Serial No.: 21-138A  
NRA/GDM: R2  
Docket Nos.: 50-280  
50-281  
License Nos.: DPR-32  
DPR-37

**VIRGINIA ELECTRIC AND POWER COMPANY**  
**SURRY POWER STATION UNITS 1 AND 2**  
**PROPOSED LICENSE AMENDMENT REQUEST**  
**REMOVAL OF REFUELING WATER CHEMICAL ADDITION TANK AND**  
**REPLACEMENT OF CONTAINMENT SUMP BUFFER**  
**SUPPLEMENTAL INFORMATION**

**RESPONSE TO NRC REQUEST FOR SUPPLEMENTAL INFORMATION**

**REMOVAL OF REFUELING WATER CHEMICAL ADDITION TANK AND  
REPLACEMENT OF CONTAINMENT SUMP BUFFER**

Figure 1 – Currently Planned NaTB Basket Locations in Unit 1 Containment

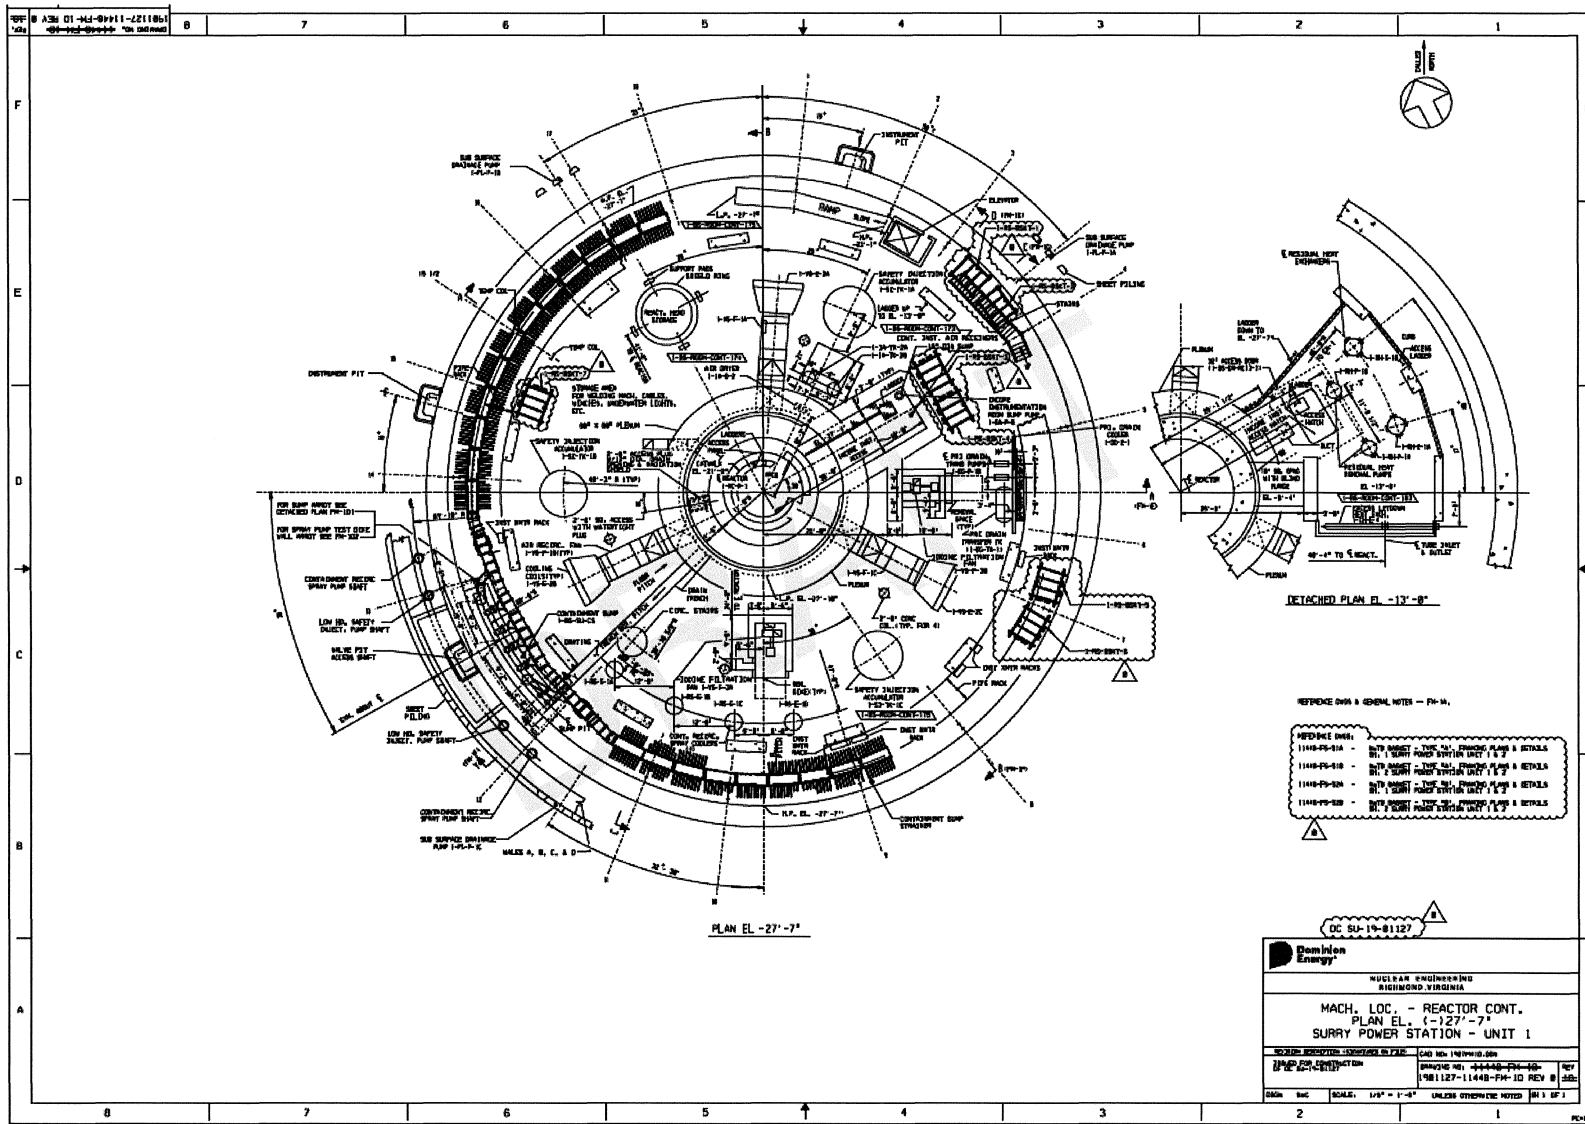
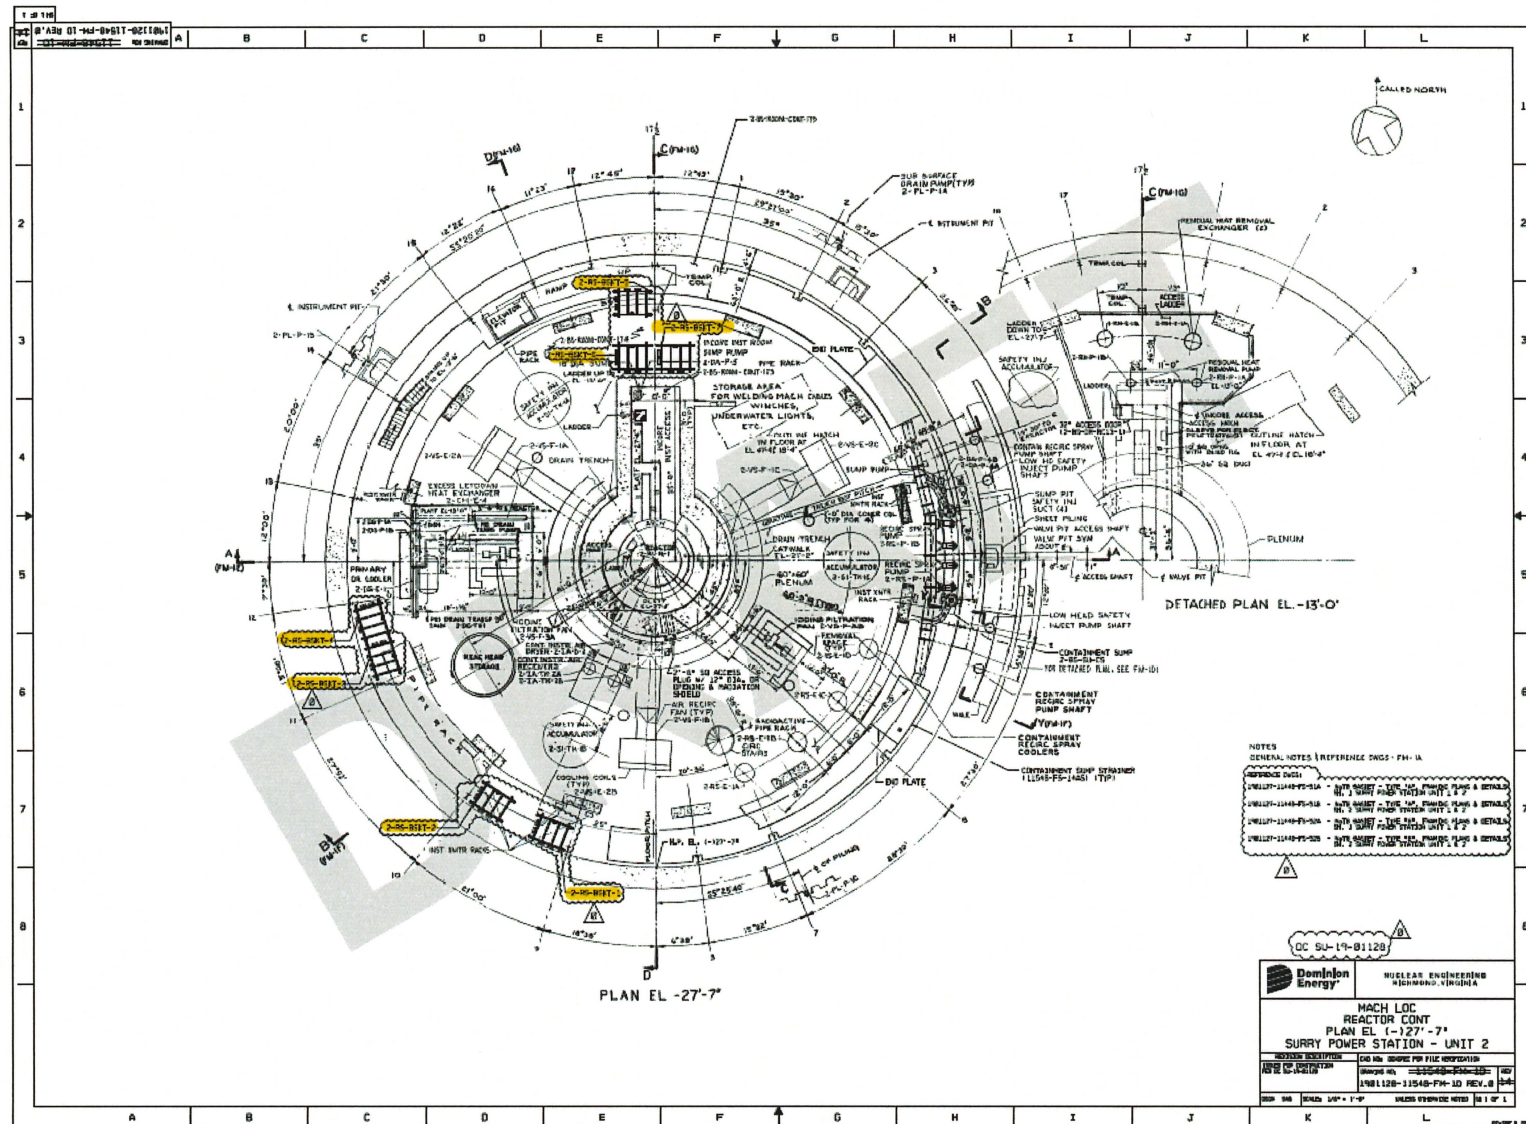
*A description of how the NaTB (sodium tetraborate decahydrate) will be stored, such as the number of baskets, size, detailed x-y-z location, and how they are designed to contain the NaTB while allowing access for the water to dissolve it.*

Seven (7) baskets will be installed in each of the Surry Unit 1 and Unit 2 Containments and will contain the required amount of NaTB chemical. Each basket will have nominal dimensions of 6' x 5' x 1.5'. The baskets will be installed on the (-)27'-7" elevation of the Surry Unit 1 and Unit 2 Containments near the annulus, as well as near the Incore Instrumentation Room. The baskets use a fine mesh supported by a perforated plate to contain the NaTB chemical that allows the containment sump water to passively dissolve the NaTB. The perforated plate and fine mesh system encompass the four basket side walls and the basket bottom. The planned installation locations of the baskets in the Surry Units 1 and 2 Containments are shown in Figures 1 and 2, respectively, and are provided for information. It should be noted that the locations could be adjusted during the design change implementation process due to unforeseen installation issues.

**Figure 3 – NaTB Basket (Example)**

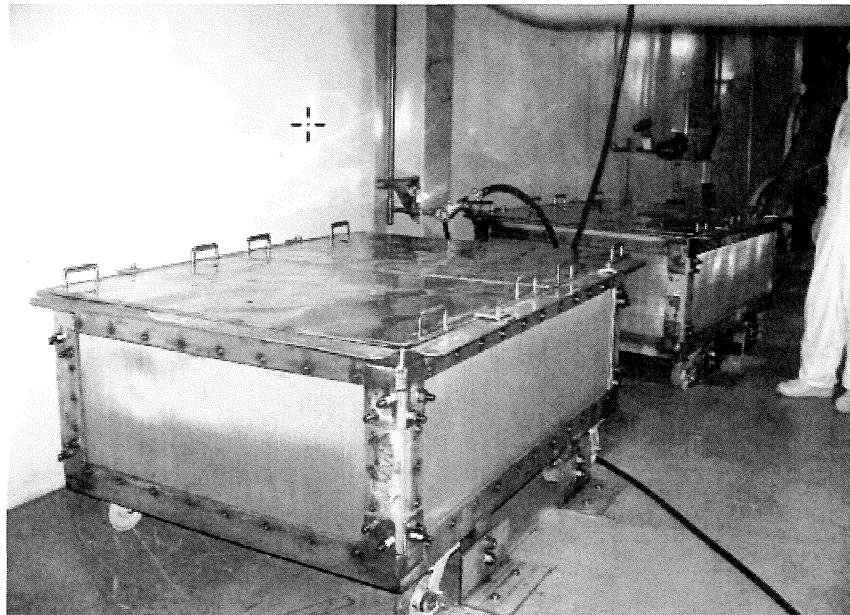
*General structural arrangement drawing(s) of the new containment chemical baskets documenting the basket support structure, including basket weight and basket design details.*

The NaTB baskets are designed of stainless steel (Type 304 SS) and have a frame with a fine mesh and perforated metal plate enclosure. The baskets are designed with four caster wheels (type 304 SS and 2205 Duplex SS) to facilitate the movement of the baskets during outages, if required. The baskets are designed with a raised bottom to provide additional surface area to dissolve the NaTB in sump water and to avoid loss of NaTB due to any inadvertent water spillage or leakage on the containment floor. The baskets include internal level indication used for inventory verification and ease of adding NaTB, as well as a removable cover which is provided with a drip edge to ensure that accumulated leaks/condensate above the baskets are directed away from the NaTB inside the basket.

The weight of one filled NaTB basket is approximately 3,975 lbs., and the weight of one fully assembled empty NaTB basket is approximately 1,425 lbs.

A picture of baskets similar to the planned baskets is provided in Figure 3.

Figure 6.1-1  
UNIT 1 ENGINEERED SAFEGUARDS SYSTEMS

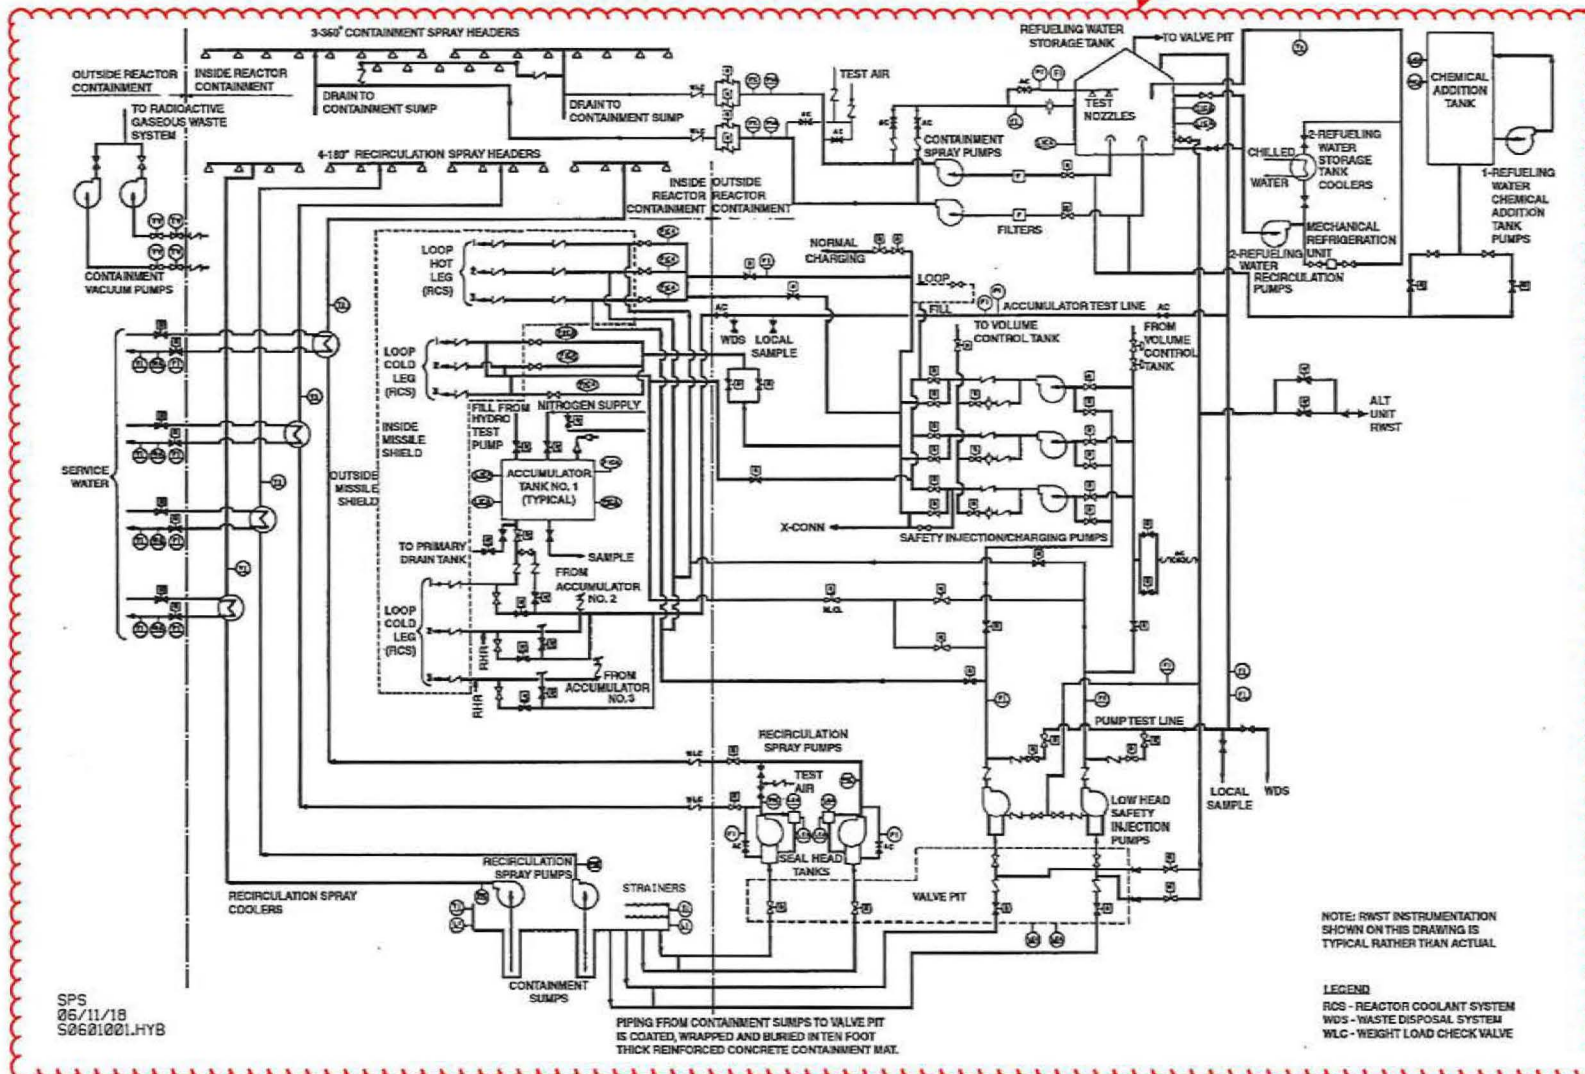
REPLACE WITH INSERT A

Sodium Tetraborate Decahydrate (NaTB) is stored in baskets inside containment to increase the alkalinity of the sump water produced during an event which exceeds the CLS high-high containment pressure actuation setpoint. The NaTB solution is recirculated by the recirculation spray subsystem to ensure effective removal of radioactive iodine (Unit 1).
